RE: Indiana Coal Council Comments on I&M IRP

ICC COMMENTS ON I&M IRP

The Indiana Coal Council (ICC) conducted a review of the Integrated Resource Plan (IRP) that Indiana Michigan Power Company (I&M) prepared and submitted to the Indiana Utility Regulatory Commission (IURC) on July 1, 2019.

Figure ES- 2. I&M New Capacity Additions – Nameplate (MW)

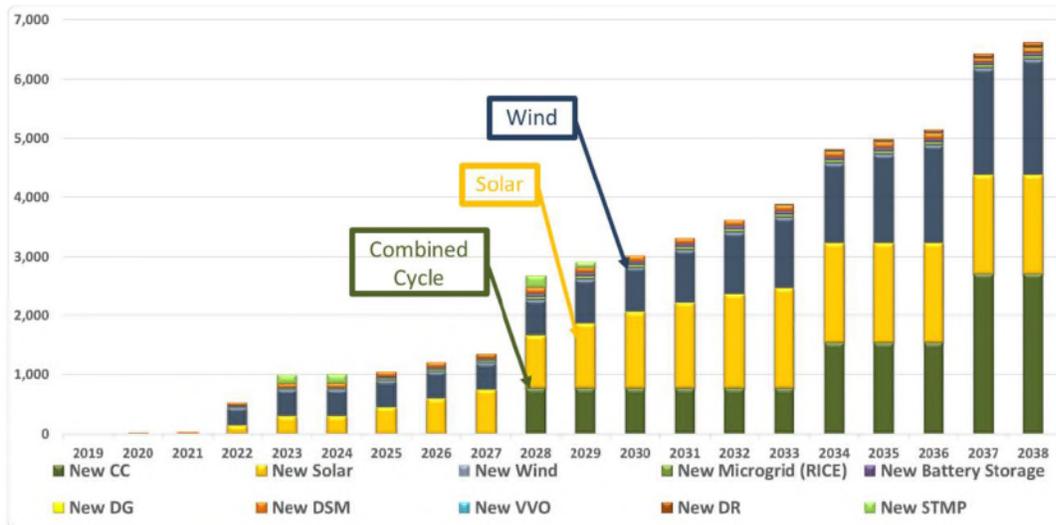
I&M analyzed a number of scenarios and identified a Preferred Plan. Under the Preferred Plan, the lease for Rockport Unit 2 would not be extended beyond 2022, Rockport Unit 1 would be retired by the end of 2028, and the Cook nuclear units 1 and 2 would operate through their current license periods, which are 2034 and 2038, respectively. These resources would be replaced by a combination of solar, energy storage, energy efficiency, and short-term market purchases through 2028 and thereafter by natural gas, solar, and battery storage, as detailed in the chart below.

Figure 4. Existing and New Capacity Additions – FIRM (MW)

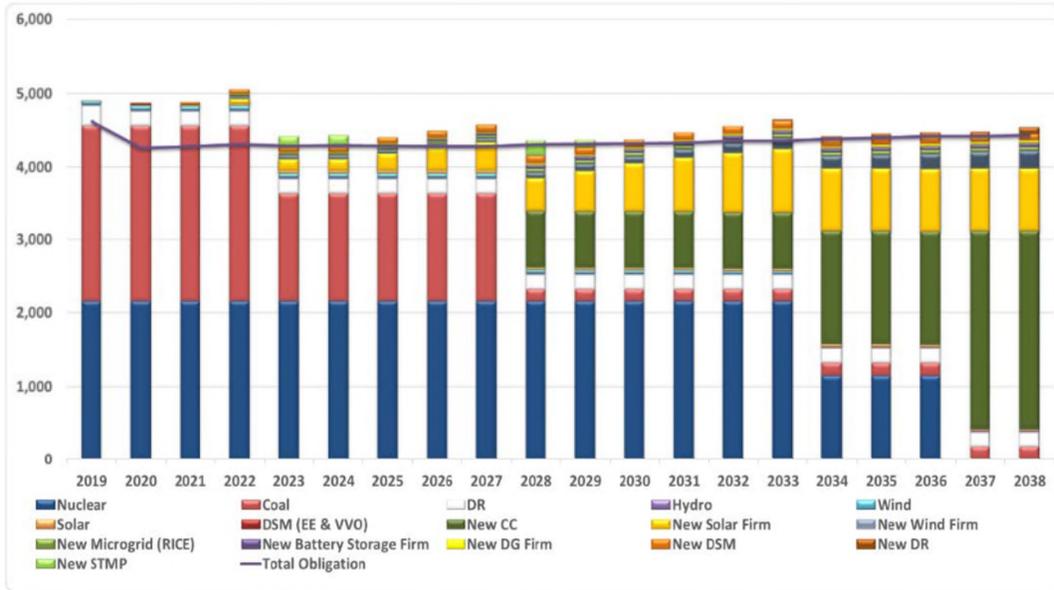
With this resource mix, more than 40 percent of I&M’s expected generation in 2040 would be from natural gas.

Figure ES- 5. I&M’s Preferred Plan Annual Energy Position (GWh)

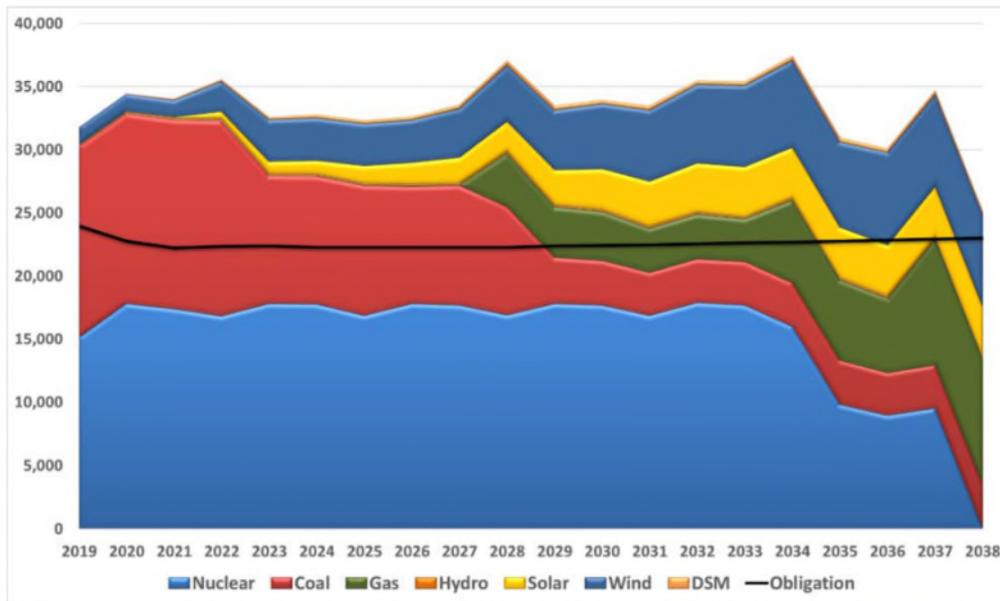
I&M's selection of natural gas to become the primary source of generation over the long-term is problematic because of I&M's assumptions related to investment life, emission profile, technology, and costs. I&M concludes that natural gas is the economic replacement for both coal and nuclear baseload generation that is needed to support its system. Therefore, beginning in 2028 with the retirement of Rockport Unit 1, large quantities of natural gas CCGT are added. The net result is that by 2040 natural gas provides 40 percent of generation.

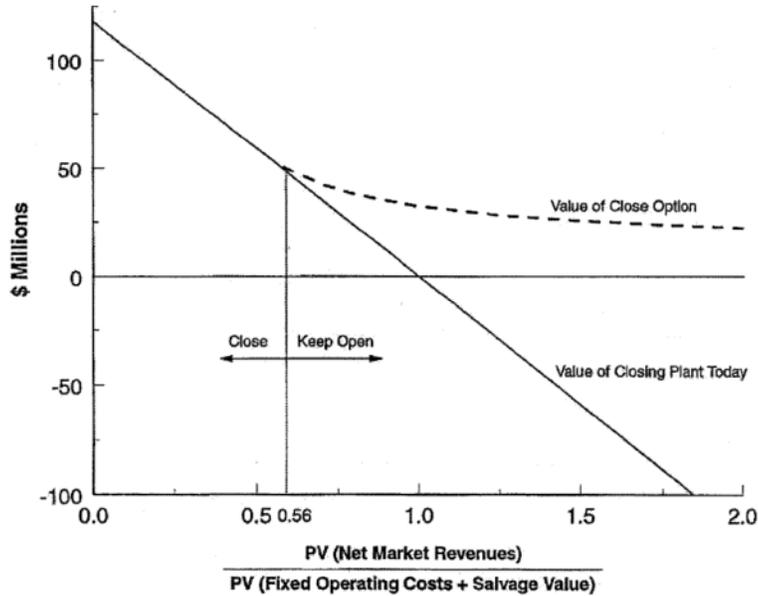
The ability to delay new investment and to make early retirements of an existing resource provides value and can be evaluated using option valuation techniques.⁹ Using these techniques shows that in the face of volatile commodity prices and an uncertain future, it can actually be value creating to continue to operate existing resources even if the expected value of operation is below zero, because there is value to holding the option to continue operating in certain future conditions. Similarly, new investment requires an expected net present value significantly greater than zero under such conditions, because there is option value in delaying investment. A graphical explanation of option value is shown below:

If a decision cannot be deferred, there is no option value (because the option has expired) and a retirement should be made when the NPV of expected cost falls below the NPV of expected revenue, i.e., a benefit/cost ratio of one and a NPV equal to zero. But if a decision can be deferred, there is option value to waiting to see if prices and revenues increase. For example, if there is \$50 million of option value, a utility would not retire at a benefit cost ratio of one, but at a benefit cost ratio of 0.56. Put another way, the utility would not exercise the option to retire a plant until the NPV cost of continued operation exceeds the option value of \$50 million, i.e., a negative \$50 million NPV of operation.
